ADDENDUM NO. 1
Issued: June 1, 2021

Solicitation #CI 21 B 00608

**Renovation of MHA High Rise Dwelling Units at Barry Towers,
Venson Center, Jefferson Square and Borda Towers, Memphis, TN**

A1.3

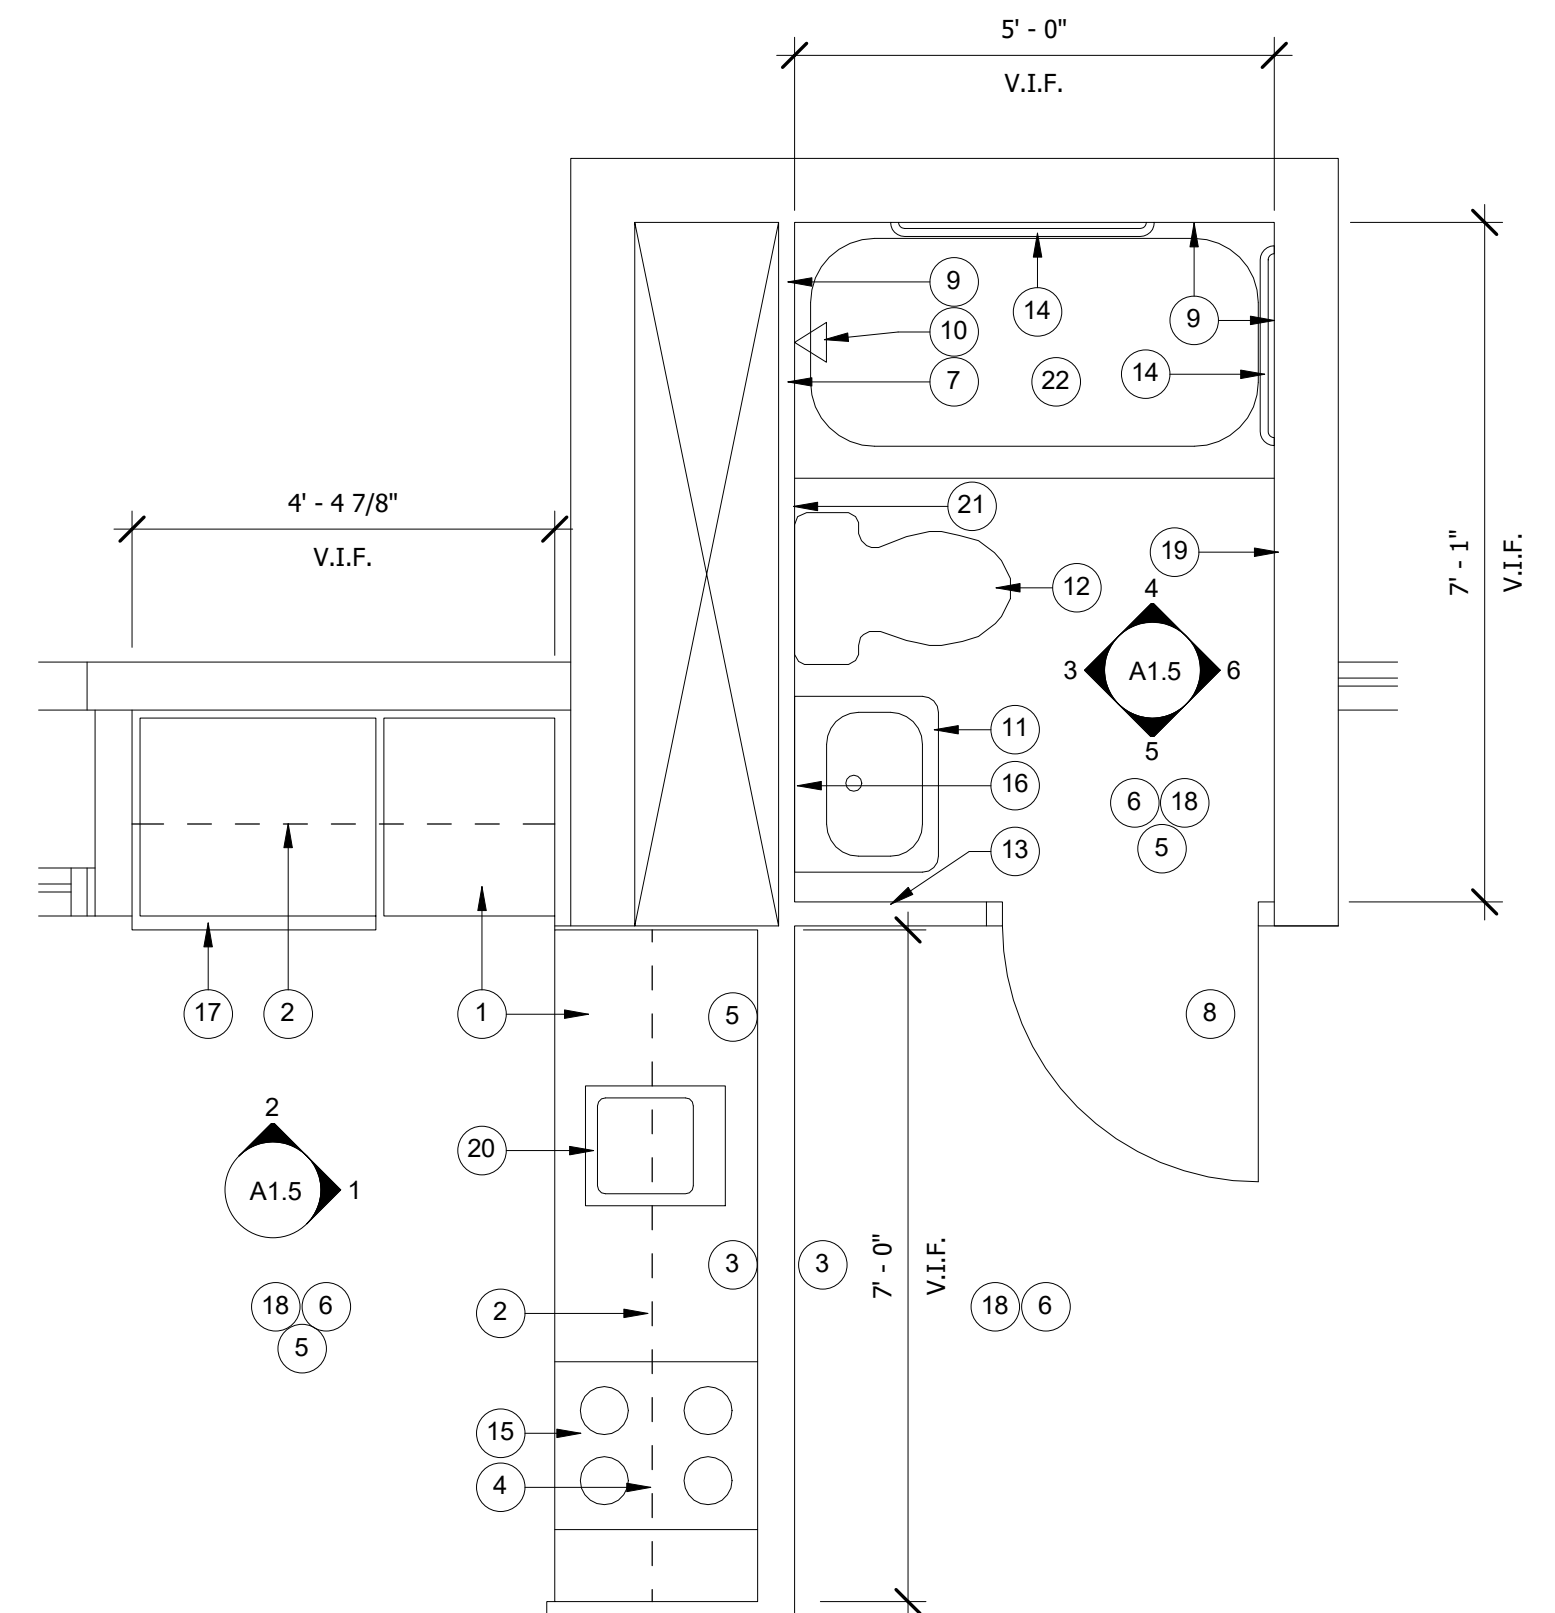
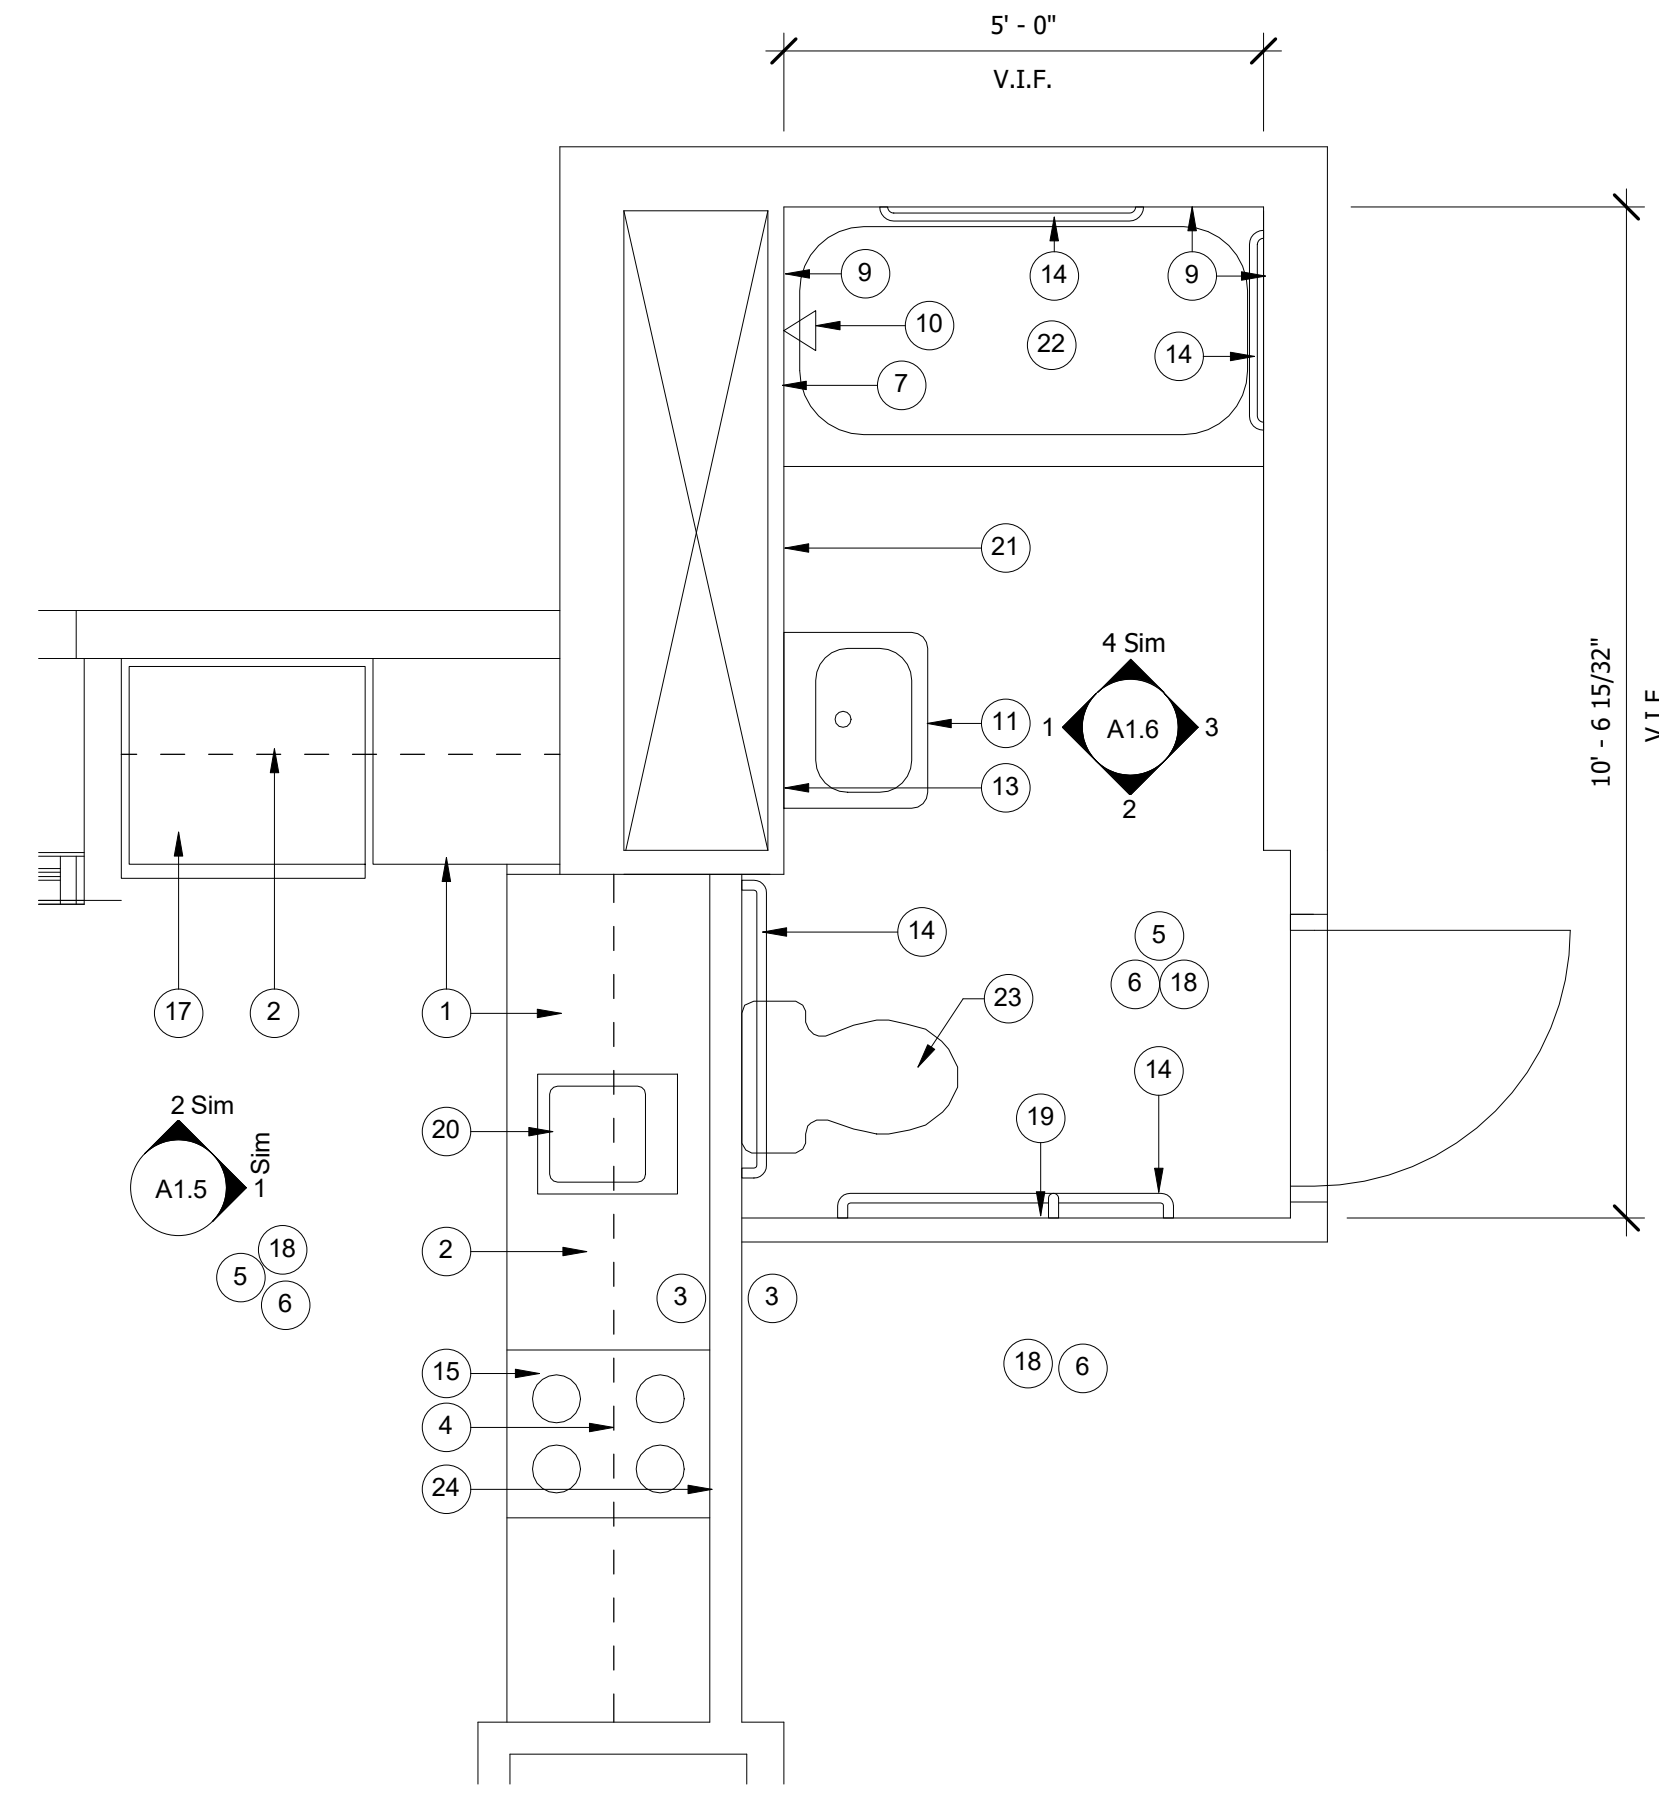
4. A1.3 Plan note 4: Is there an allowance for if the duct work is not in adequate shape for connection?

REPNSE: Remove existing damper from hood exhaust duct. Provide and install new vent hood. Extend new 8” ductwork from new vent hood to existing ductwork in chase. Provide and install new two position damper in ductwork and interlock with hood to open when hood is on and close when hood is off.

REFER TO SHEET A1.3.

4 BARRY TOWER- NEW PTAC ELEVATION
1/2" = 1'-0"

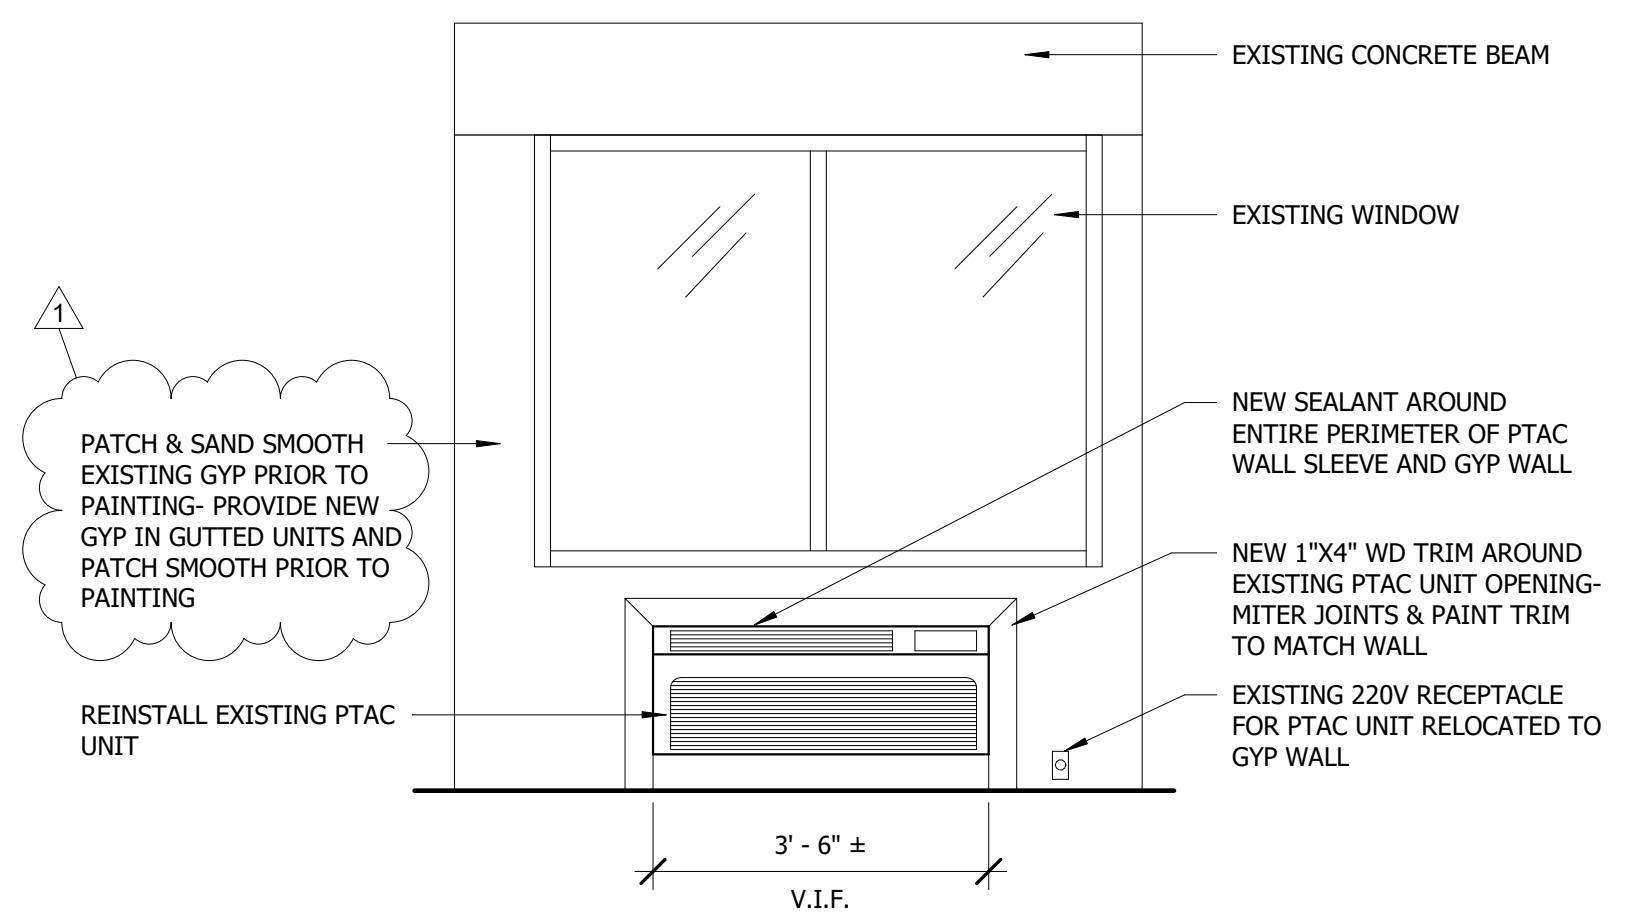
7. Per Sheet A1.6: notes to reinstall existing PTAC units
 - a. In our walk through, it appears some PTAC's were missing, or don't appear to be in working order. Please advise.

RESPONSE: Missing/non-functional PTAC Units shall be owner furnished and owner installed.

5 VENSON CENTER- BATHROOM ELEVATION B
1/2" = 1'-0"

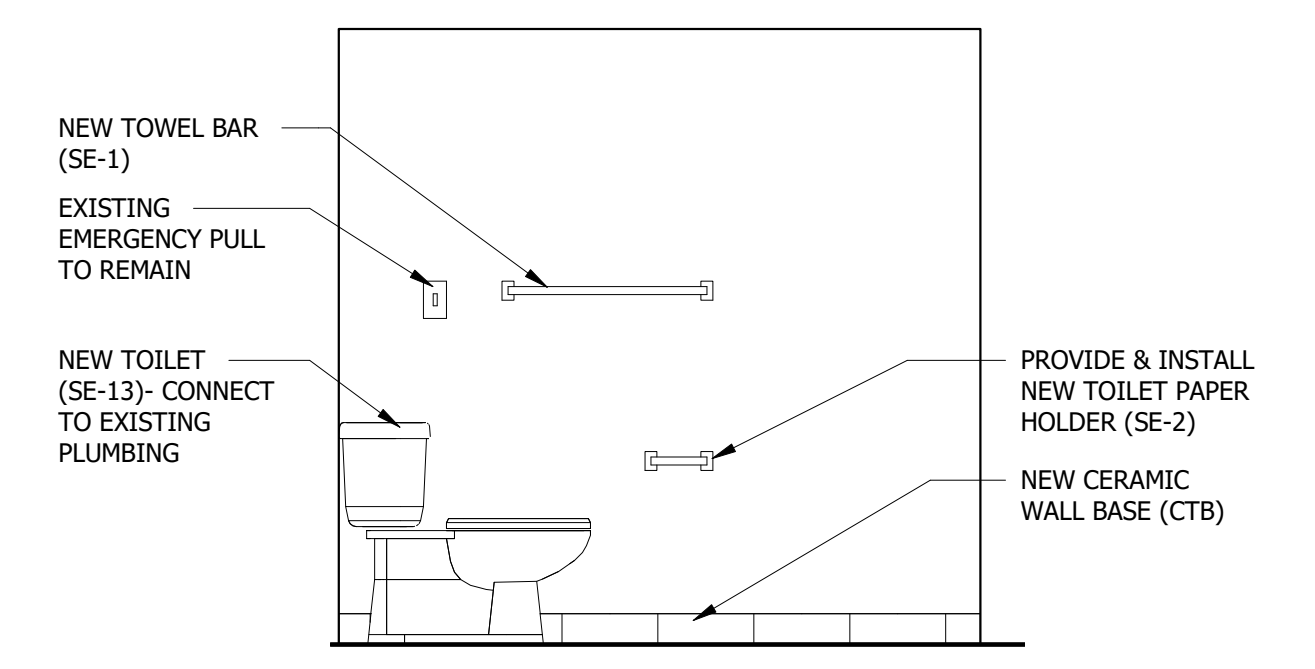
5. A2.6 Detail 5: indicates Existing shelves to be painted. All other notes indicate removal of shelves and replace with new. Please clarify.

RESPONSE: Shelves and supports will be new.
